Memorandum

Project: 18-22 Haverstock Hill, Chalk Farm
Subject: Commercial Noise Assessment
Prepared: Tim Fox
Date: 24 May 2019
Reference: 19/0013/M2 **Revision:** 1 **Approved:** JB

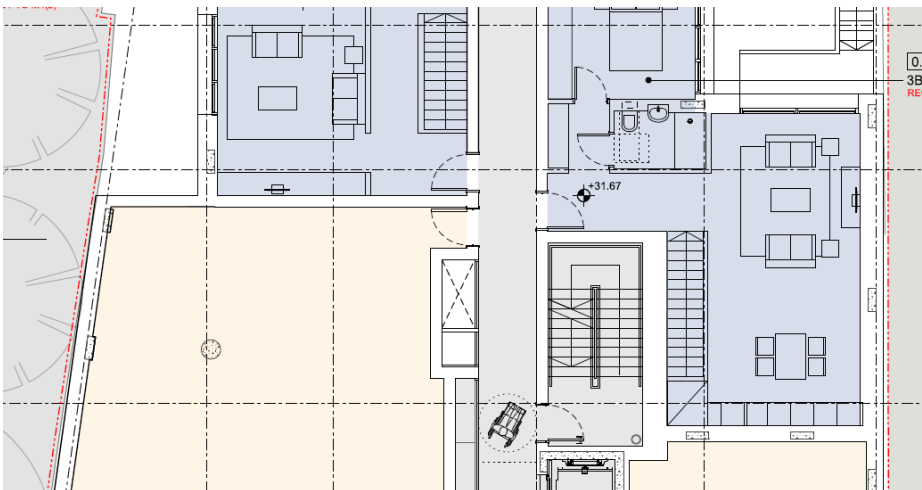
- 5.1 Current proposals show the rear of one of the commercial units has a doorset in close proximity to the front doors for two of the properties, as shown on the plan below.

- 5.2 To mitigate noise transfer through these doorsets, we would recommend the doorsets are specified to achieve a performance of R_w 35 dB. This can typically be achieved by a well fitted 54mm timber door. Compression or wipe seals should be used around the door's perimeter along with a threshold seal beneath.
